TOYOTA TECHNICAL SERVICE BULLETIN

REF.: BRAKES
NO.: BR95-003
DATE: AUGUST 18, 1995
MODEL: ALL MODELS

INTRODUCTION OF BRAKE SHIM KITS & BRAKE FITTING KITS

NEW PARTS:

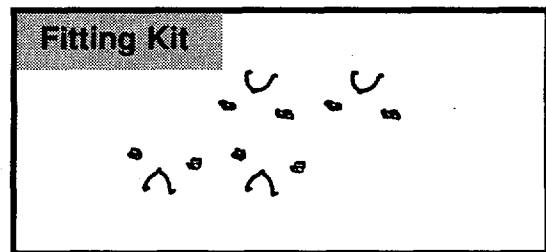
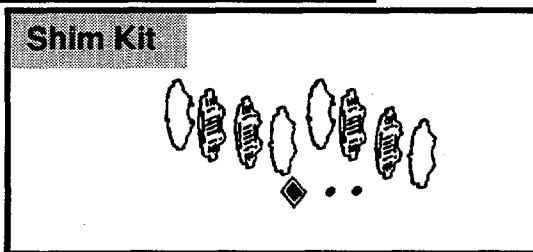
Full brake kits, with complete hardware, have been discontinued. Shim kits and fitting kits for the front and rear brakes are now available separately, along with previously released pad kits.

DISCONTINUED PARTS:

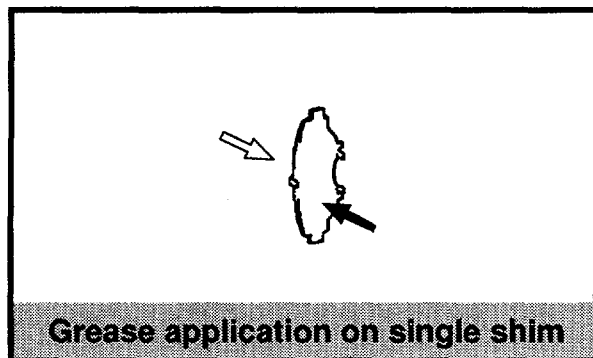
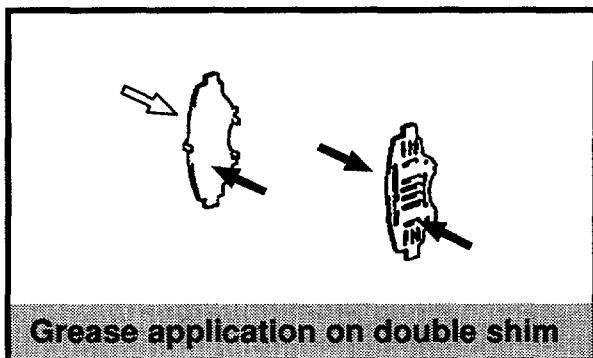
1. All vehicles are to be inspected to insure that the integrity of the complete brake system is maintained. When replacing worn pads, you should replace the shims, wear indicators, (wear indicators may be riveted onto pads for some models) and shim grease at the same time using the pad kits and new shim kit. Vehicles found to need extensive hardware replacement, including anti-squeal springs and support plates, should be repaired using the pad kit, shim kit and fitting kit, which together include all hardware components.
2. When applying shim grease, apply a thin layer over the shim faces as indicated below.

➡ = Apply shim grease on this face.

➡ = Do not apply shim grease on this face (piston side).
